SUBJECT: REACTOR PRESSURE VESSEL PRESSURE-TEMPERATURE CURVES, SUSQUEHANNA  
STEAM ELECTRIC STATION, UNITS 1 AND 2 (TAC NOS 80224 AND 80225)

Amendment No. 116  
License No. NPF-14

Amendment No. 85  
License No. NPF-22

SAFETY EVALUATION BY THE OFFICE OF NUCLEAR REACTOR REGULATION  
RELATED TO AMENDMENT NO. 116 TO FACILITY OPERATING LICENSE NO. NPF-14  
AMENDMENT NO. 85 TO FACILITY OPERATING LICENSE NO. NPF-22  
PENNSYLVANIA POWER & LIGHT COMPANY  
ALLEGHENY ELECTRIC COOPERATIVE, INC.  
SUSQUEHANNA STEAM ELECTRIC STATION, UNITS 1 AND 2  
DOCKET NOS. 50-387 AND 388

Figure 3.4.6.1-1

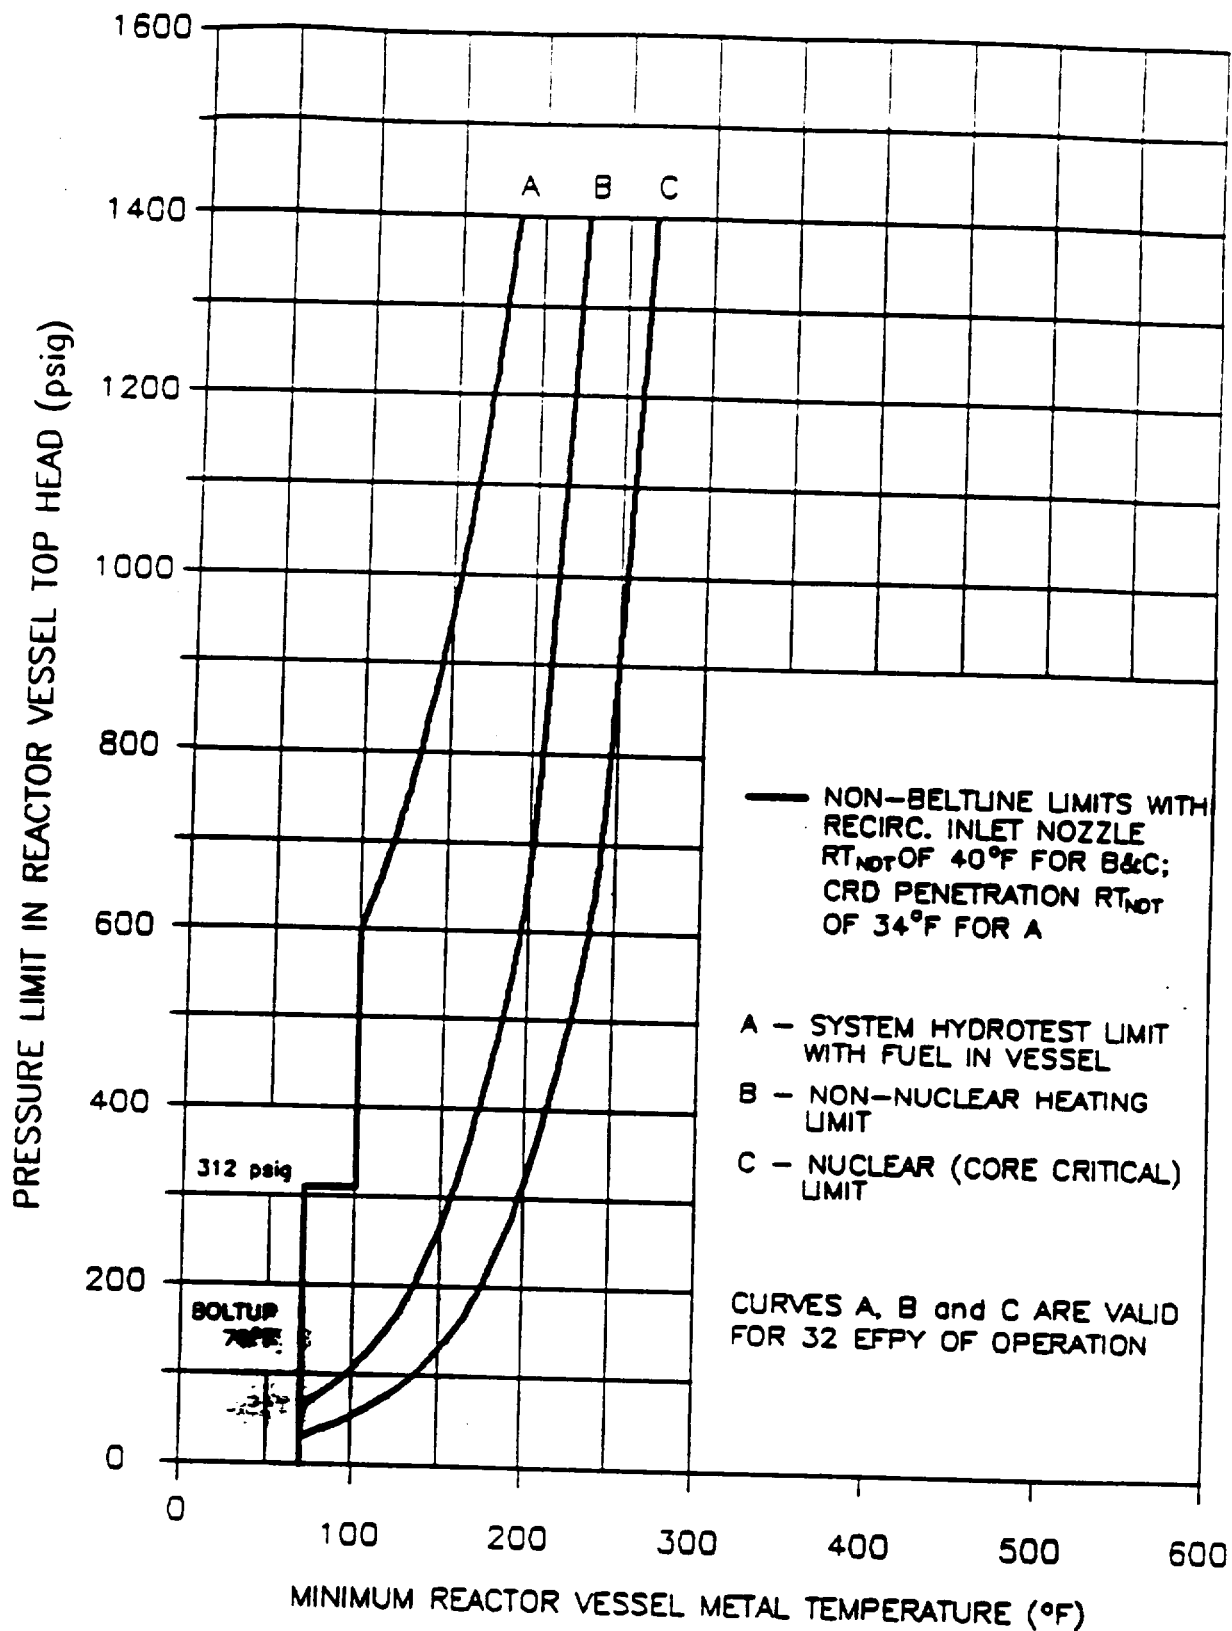
- 3.4.6.1 The reactor coolant system temperature and pressure shall be limited in accordance with the limit lines shown on Figure 3.4.6.1-1 for hydrostatic or leak testing, heatup by non-nuclear means, cooldown following a nuclear shutdown and low power PHYSICS TESTS, and operations with a critical core other than low power PHYSICS TESTS, with:
- a. A maximum heatup of 100°F in any 1-hour period,
  - b. A maximum cooldown of 100°F in any 1-hour period,
  - c. A maximum temperature change of less than or equal to 20°F in any one hour period during inservice hydrostatic and leak testing operations above the heatup and cooldown limit curves, and
  - d. The reactor vessel flange and head flange temperature greater than or equal to 70°F when reactor vessel head bolting studs are under tension.

- 4.4.6.1.2 The reactor coolant system temperature and pressure shall be determined to be to the right of the criticality limit line of Figure 3.4.6.1-1 within 15 minutes prior to the withdrawal of control rods to bring the reactor to criticality and at least once per 30 minutes during system heatup.

- 4.4.6.1.3 The reactor vessel material specimens shall be removed and examined to determine reactor pressure vessel fluence and embrittlement as a function of time and THERMAL POWER as required by 10 CFR 50, Appendix H. The results of these fluence and embrittlement determinations shall be used to update the curves of Figure 3.4.6.1-1.

Bases Figure B 3/4.4.6-1

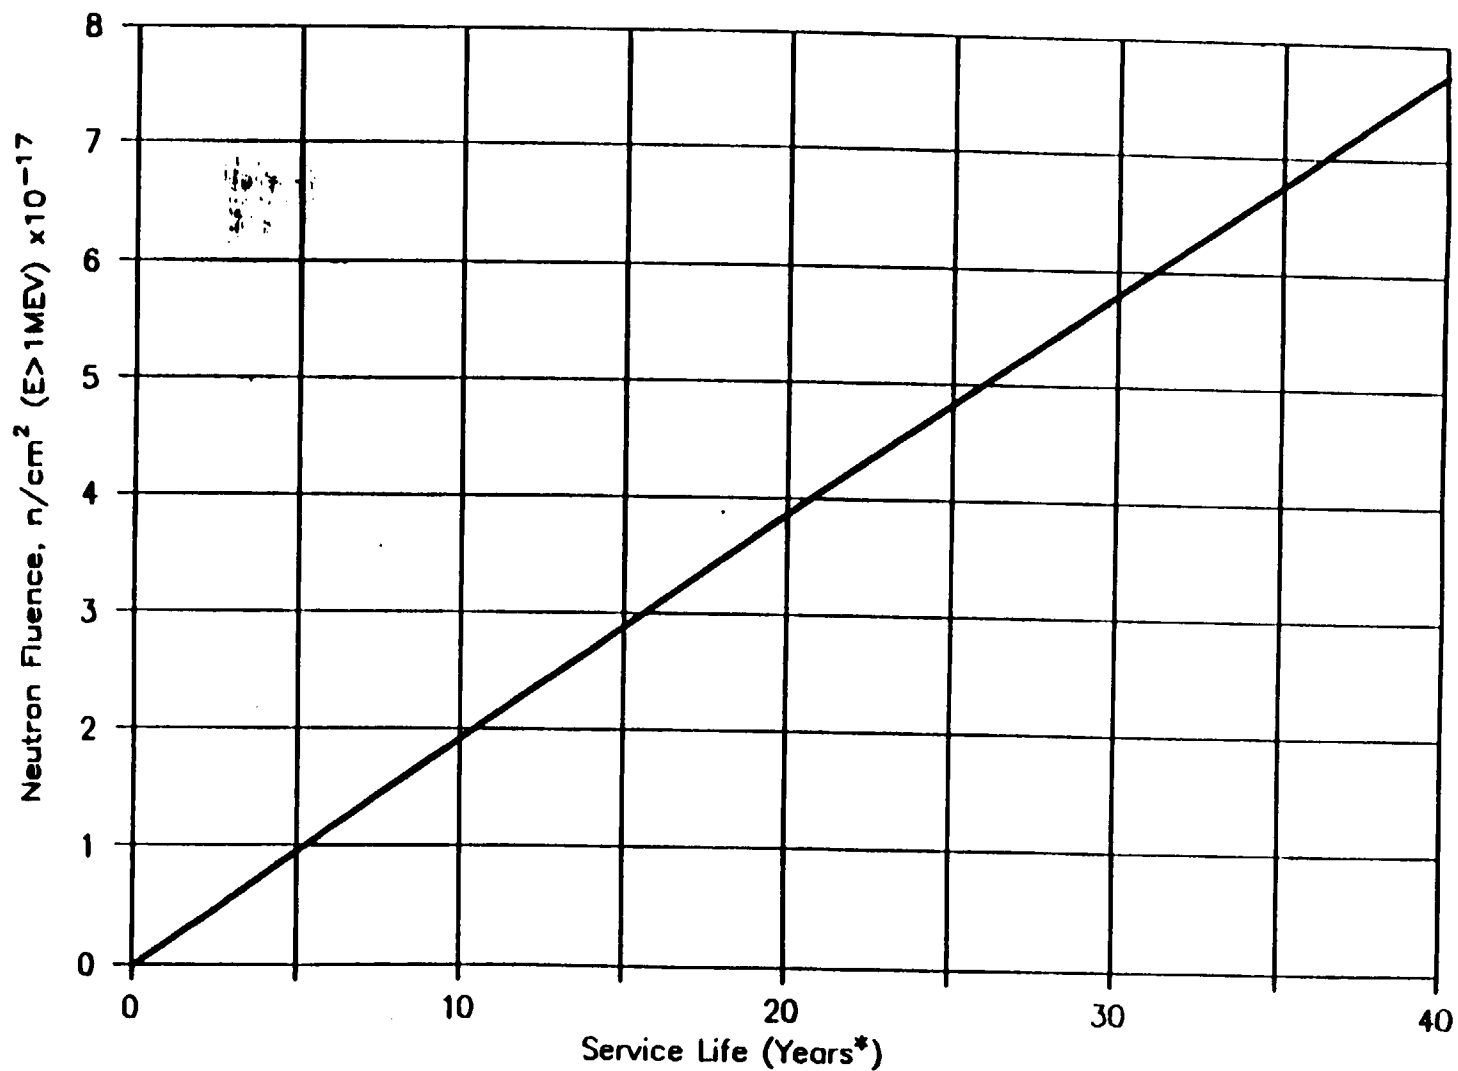
The reactor vessel materials have been tested to determine their initial  $RT_{NDT}$ . The results of these tests are shown in Table B 3/4.4.6-1. Reactor operation and resultant fast neutron, E greater than 1 MeV, irradiation will cause an increase in the  $RT_{NDT}$ . Therefore, an adjusted reference temperature, based upon the fluence, nickel content and copper content of the material in question, can be predicted using Regulatory Guide 1.99, Revision 2, "Radiation Embrittlement of Reactor Vessel Materials." The pressure/temperature limit curve, Figure 3.4.6.1-1, includes predicted adjustments for this shift in  $RT_{NDT}$  for the 32 EFPY condition.

Figure 3.4.6.1-1

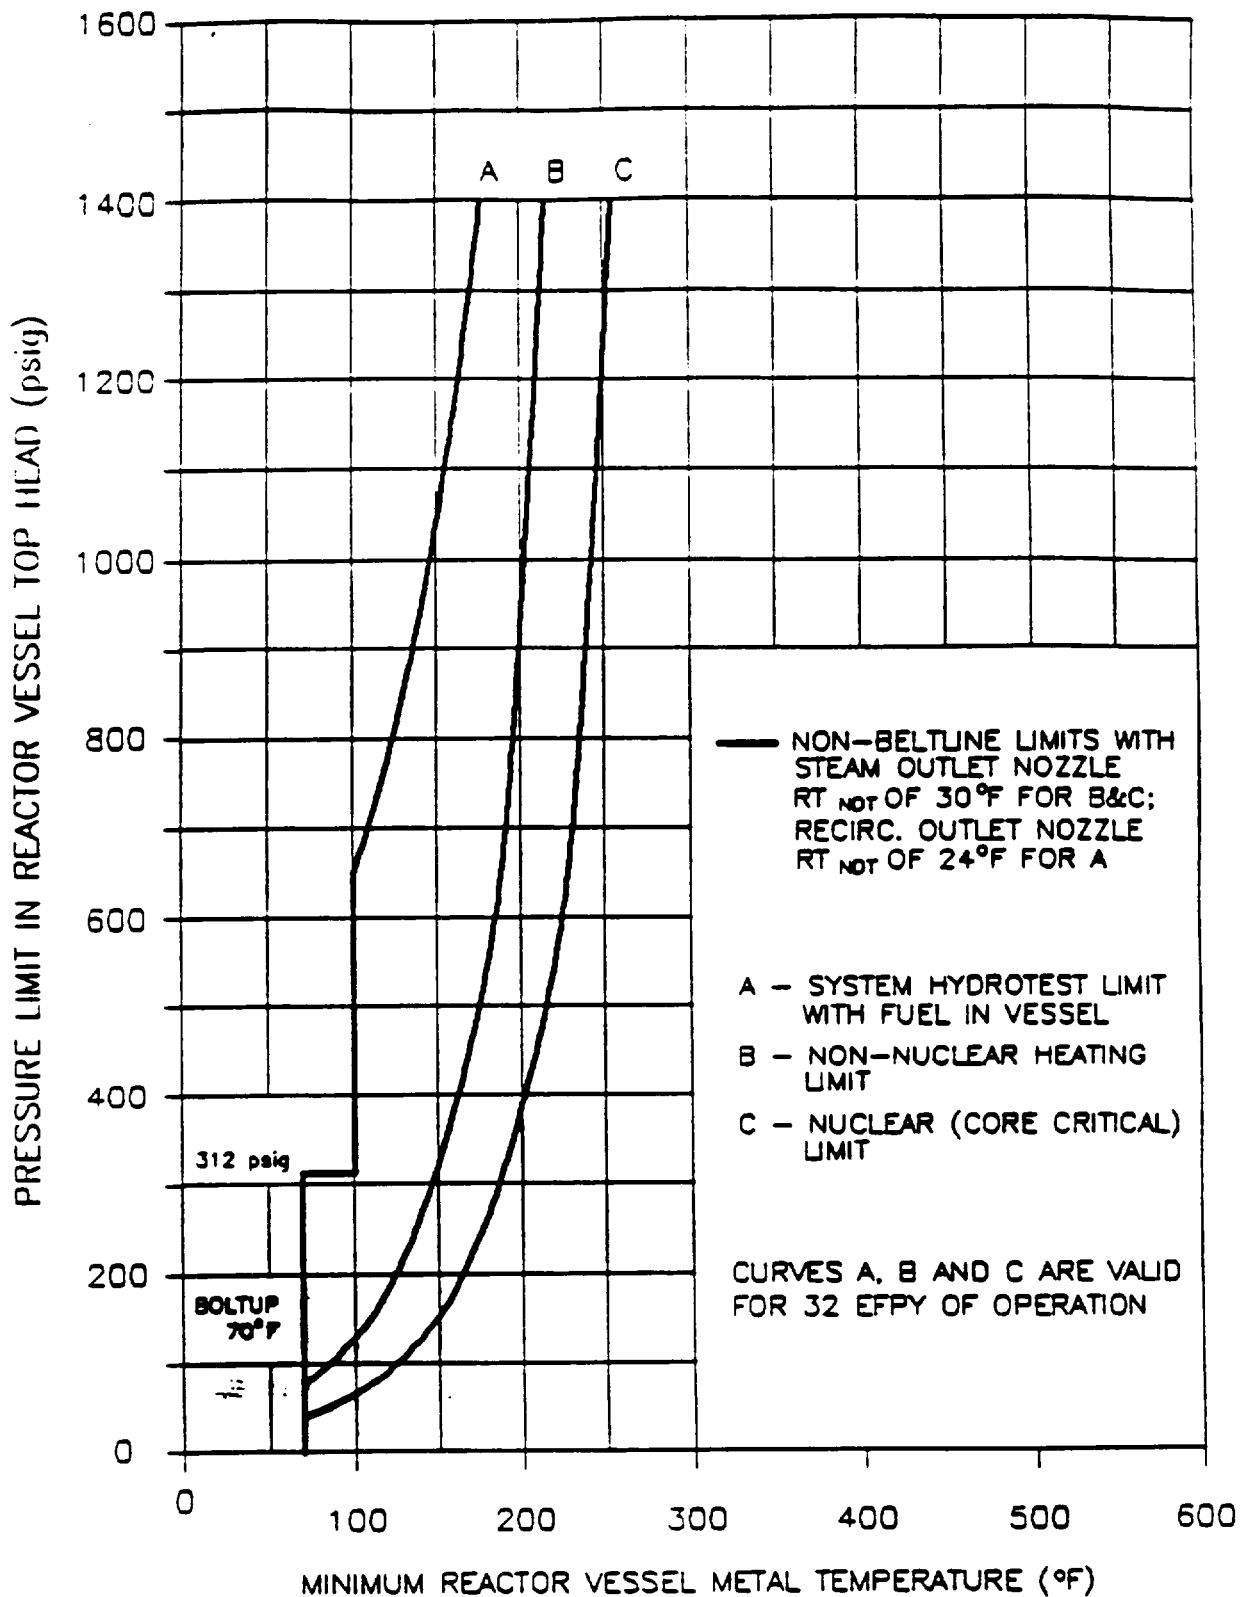
- 4.4.6.1.2 The reactor coolant system temperature and pressure shall be determined to be to the right of the criticality limit line of Figure 3.4.6.1-1 within 15 minutes prior to the withdrawal of control rods to bring the reactor to criticality and at least once per 30 minutes during system heatup.

- 4.4.6.1.3 The reactor vessel material specimens shall be removed and examined to determine reactor pressure vessel fluence and embrittlement as a function of time and THERMAL POWER as required by 10 CFR Part 50, Appendix H. The results of these fluence and embrittlement determinations shall be used to update the curves of Figure 3.4.6.1-1.

Fast Neutron Fluence (E>1 Mev) at I.D. Surface as a Function of Service Life\*  
Bases Figure B 3/4.4.6-1

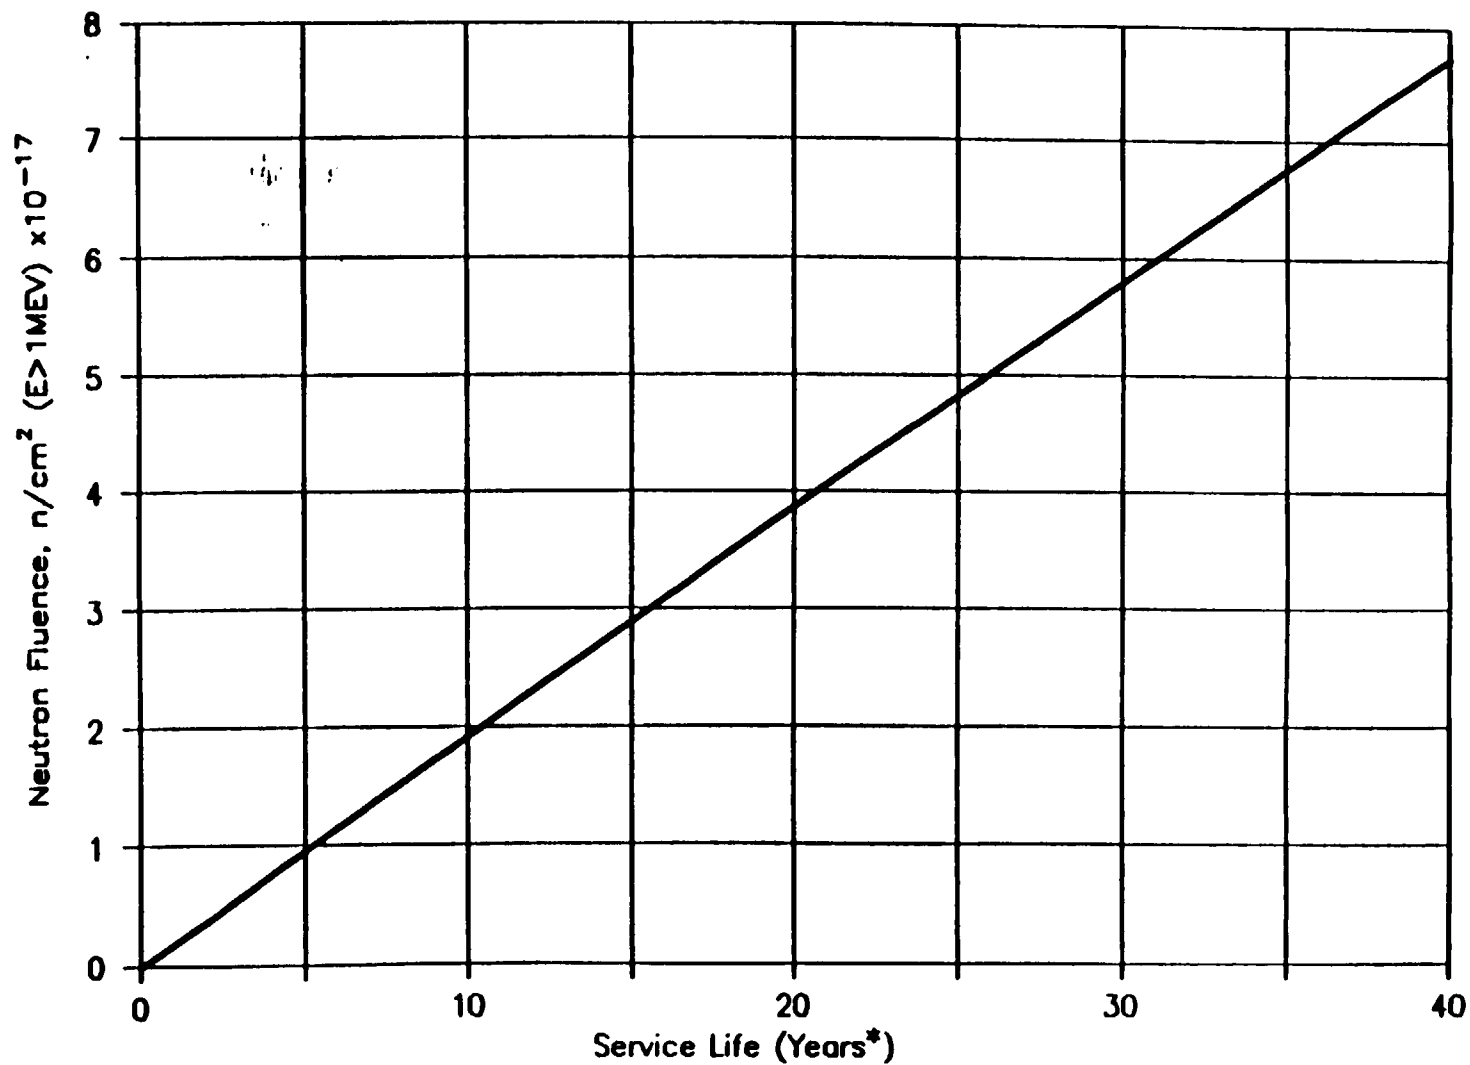
The reactor vessel materials have been tested to determine their initial  $RT_{NDT}$ . The results of these tests are shown in Table B 3/4.4.6-1. Reactor operation and resultant fast neutron, E greater than 1 MeV, irradiation will cause an increase in the  $RT_{NDT}$ . Therefore, an adjusted reference temperature, based upon the fluence, nickel content and copper content of the material in question, can be predicted using Regulatory Guide 1.99, Revision 2, "Radiation Embrittlement of Reactor Vessel Materials". The pressure/temperature limit curve, Figure 3.4.6.1-1 includes predicted adjustments for this shift in  $RT_{NDT}$  for the 32 EFPY condition.
